Proposed Revisions to a Standard Plans Index

Index Number: 455-030

Index Title: 30" SQUARE PRESTRESSED CONCRETE PILE

Reverted to the previous version of the Standard.

LAST REVISION 11/01/22	REVISION	DESCRIPTION:		FY 2023-24 STANDARD PLANS	30" SQUARE PRESTRESSED CONCRETE PILE	INDEX 455-030	SHEET 1 of 1
---------------------------	----------	--------------	--	-------------------------------------	---	-------------------------	------------------------

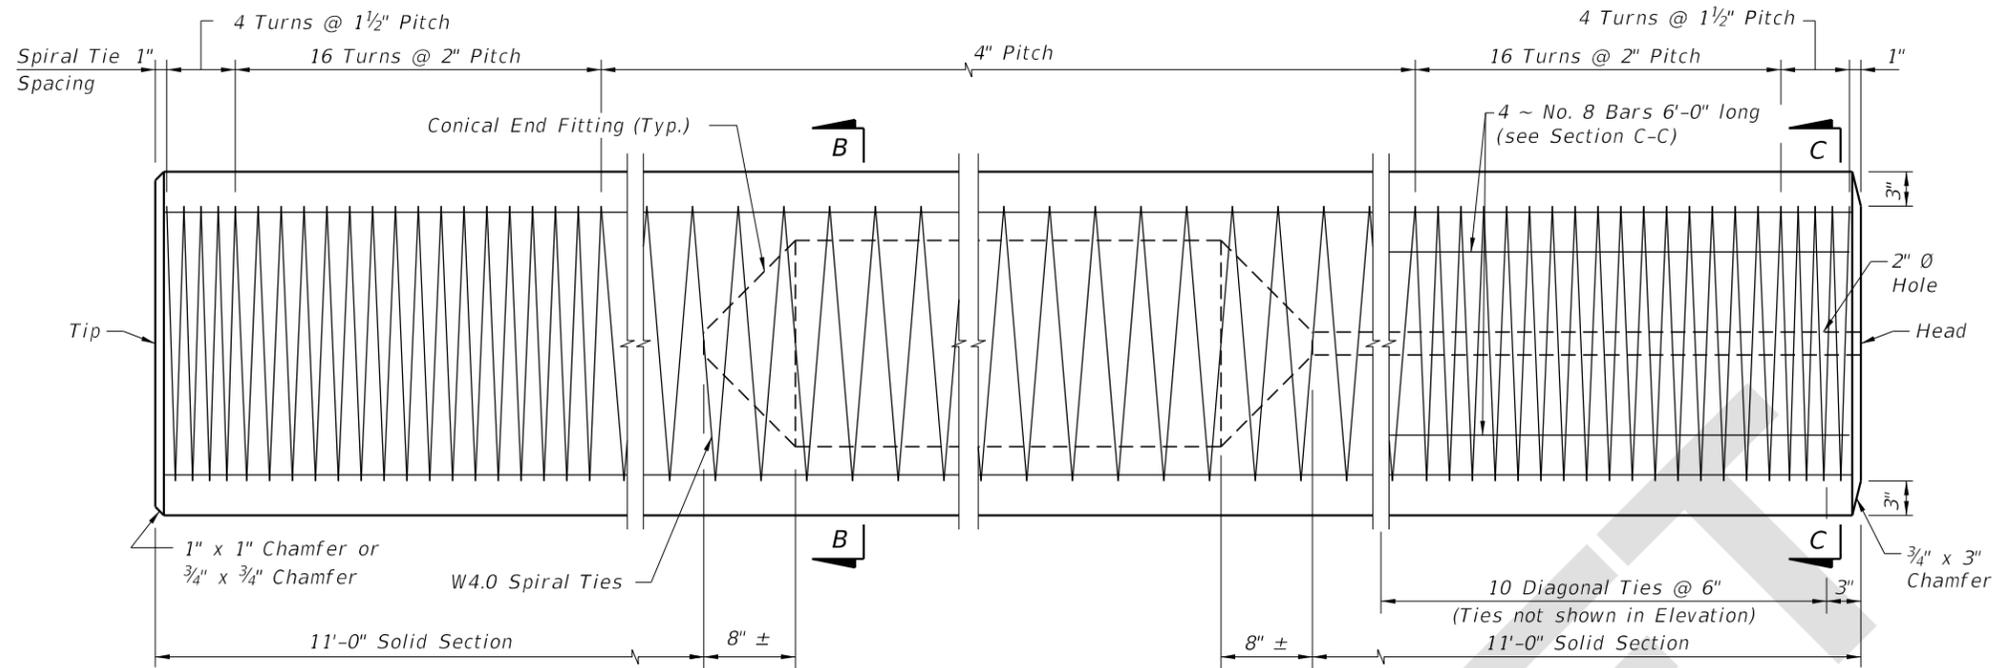
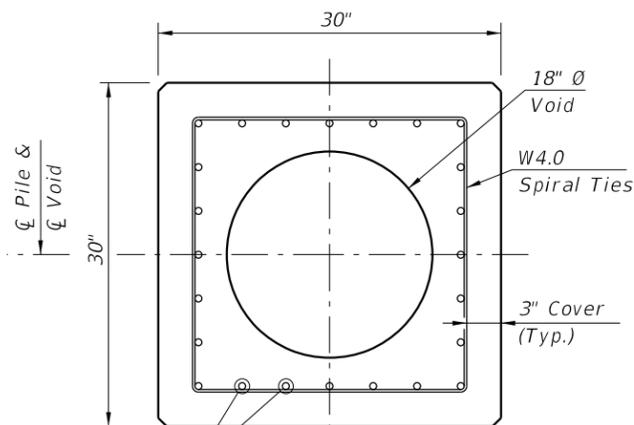
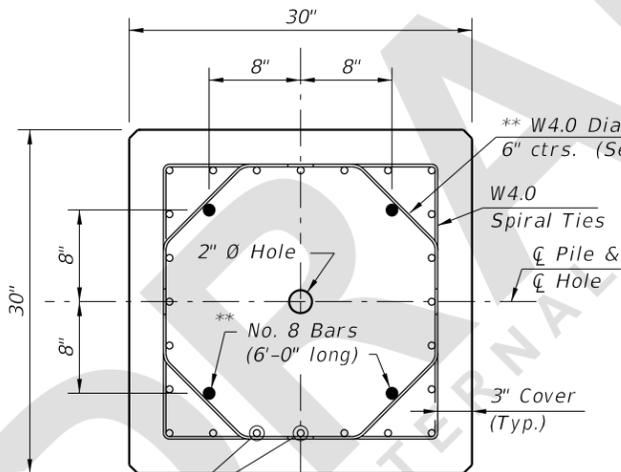
- Work this Index with Index No. ~~20600~~ - Notes and Details for Square Prestressed Concrete Piles and Index No. ~~20601~~ - Square Prestressed Concrete Pile Splices.

- Work this Index with Index 455-001 - Notes and Details for Square Prestressed Concrete Piles and Index 455-002 - Square Prestressed Concrete Pile Splices.
